Amendments to EnergyAustralia's Network Standard NS 0126, *Specification for High Voltage Overhead Conductors*, February 1998.

This Customer Installation Advice (CIA) amends Network Standard (NS) 0126, *Specification for High Voltage Overhead Conductors*, which will be updated in due course.

Figure 1. Vegetation Trimming Clearances - Bare and Covered Conductors (Cross Sectional View)

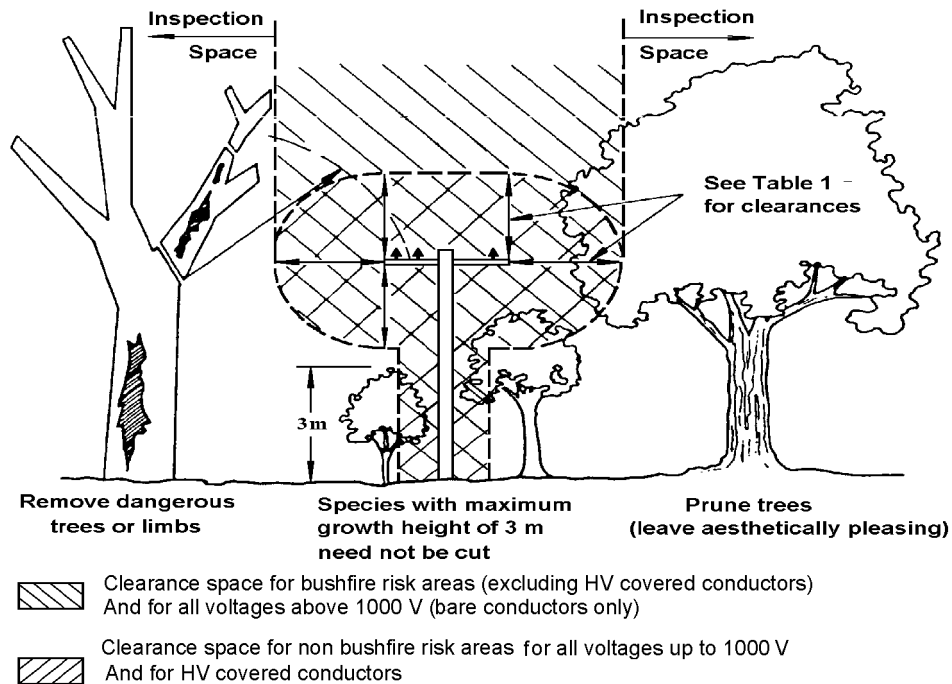
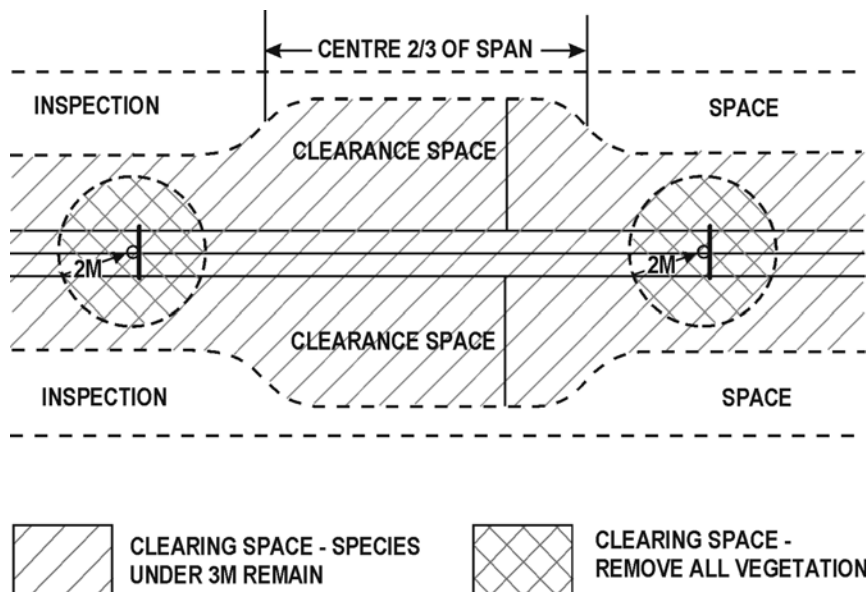
1. It is desirable to always achieve the clearance requirements of Figure 1, especially the clear space above power lines in bushfire risk areas. If this is not practicable, a minimum of 3 metres is to be achieved, and all dead and obviously dying branches which may interfere with the mains, are to be removed.

2. Where the Contractor/Council/Owner/Occupier considers that by allowing tree trunks or major branches of large healthy trees to remain within the specified clearance area:

- no one climbing the trunks or branches will be able to come into contact with the overhead construction, and
 - there will be no threat posed to the overhead construction, and

- there will be no risk of bushfire being caused by the trunks or branches; the matter shall be referred to EnergyAustralia for written approval to leave the trunks or branches within the specified clearance area.

3. Where vegetation is interfering with a pole, standard or stay wire, or any attachment on a pole or standard, a minimum vegetation clearance of two metres is to be achieved in all directions around the pole, standard, stay wire and attachment. Where it is impractical for this clearance to be achieved, vegetation is to be trimmed so that the pole, standard, stay wire and any attachment on the pole or standard, can be safely accessed. Vegetation must be cleared to enable each pole to be safely accessed from a ladder facing oncoming traffic, without interference to pedestrians or vehicles. Trees and tree branches must be cleared where necessary to prevent unauthorised access to pole steps or other pole attachments which are normally out of reach.

Figure 2. Vegetation Trimming Clearances - Aerial Bundled Cable Systems

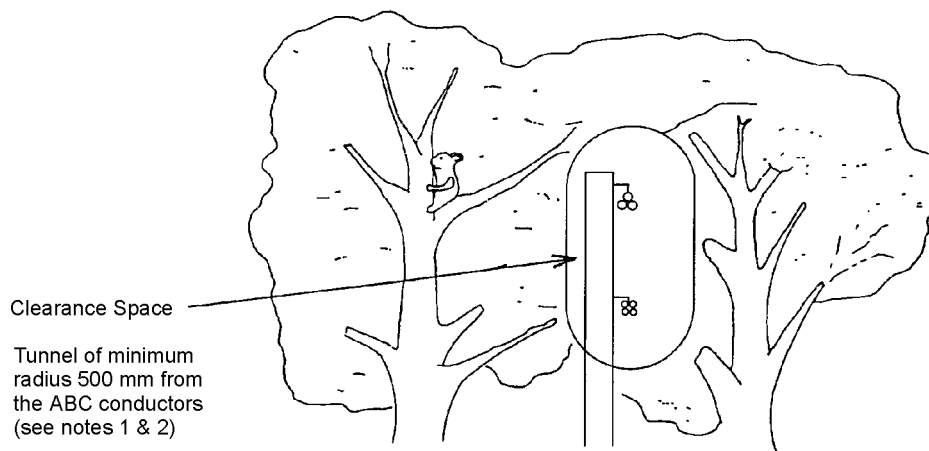
Where Aerial Bundled Cables are installed, branches which are less than 15 mm in diameter and which are not in constant contact with the cables may remain within the specified clearance area.

1. Trim any branches or twigs in the aerial bundled cable clearance tunnel or which will encroach into the tunnel within the growing cycle (typically 1 year), which are thicker than 15 mm in diameter or where the branch or twig is in constant contact with the cables. The clearance tunnel should allow for variation in sag between support structures. See Table 1 for clearance requirements.
2. Leaves and twigs are otherwise allowed to remain in the clearance tunnel.
3. Vegetation and branches which overhang or nearly overhang the clearance tunnel and which are obviously likely to break and fall onto the conductors within the growing cycle (typically 1 year) should be trimmed and removed.
4. Access to support structures for construction and maintenance needs to be allowed, to ensure reliability and staff safety during operations and maintenance works.

**Figure 3. Vegetation Trimming Clearances –
Street Lighting Luminaires (Lanterns)**

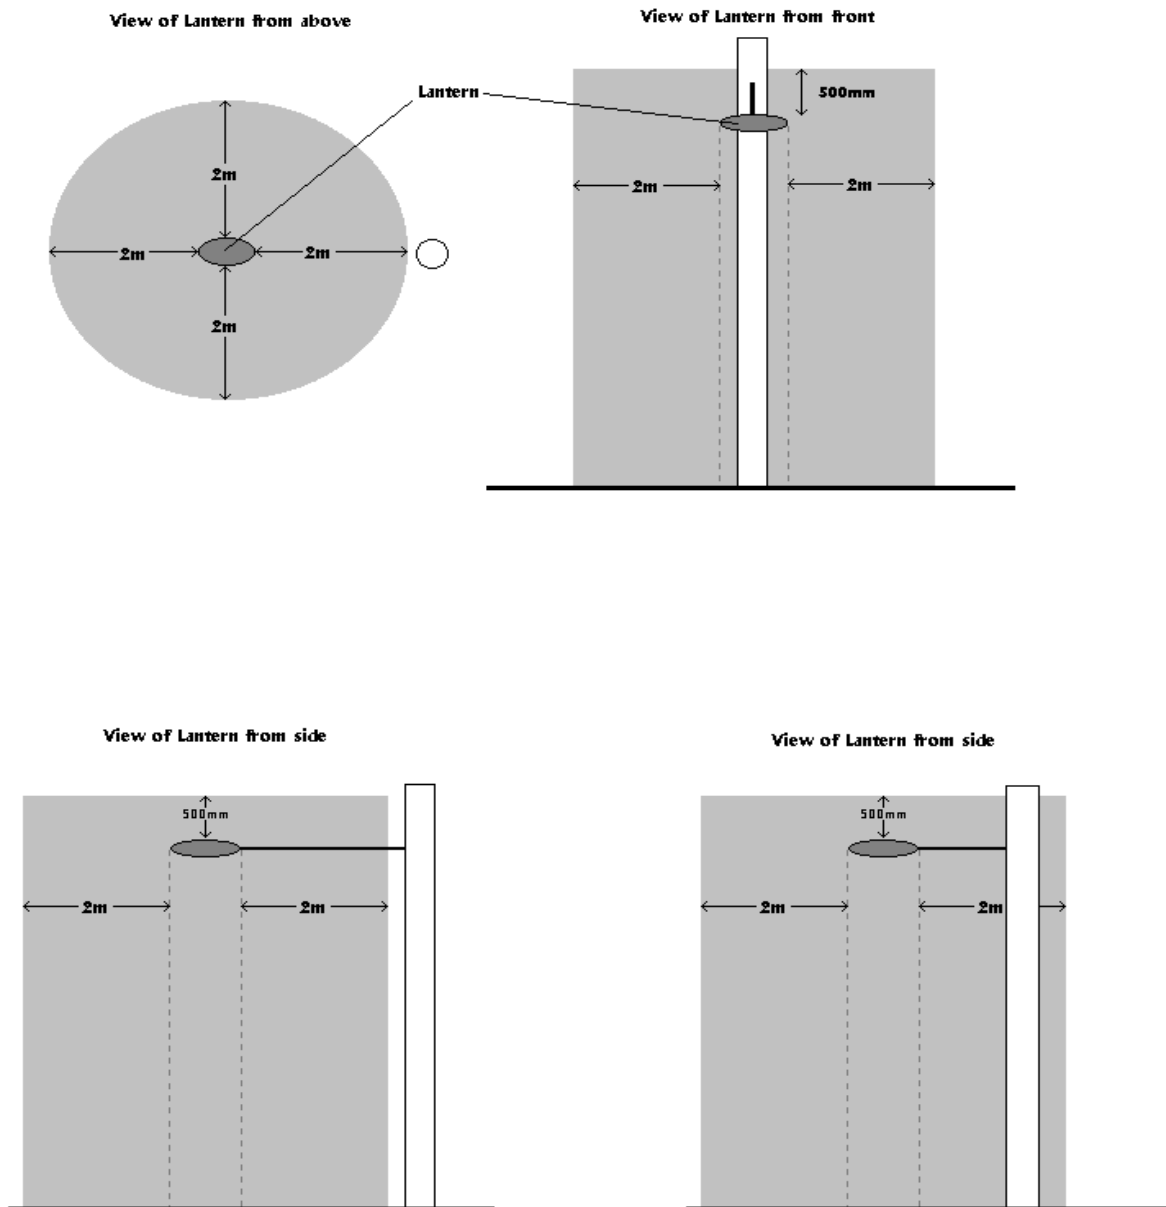
Vegetation is to be trimmed to allow a minimum of 2 metres horizontal clearance from the head of the lantern and extending in the vertical plane from 500mm above the lantern to groundline.
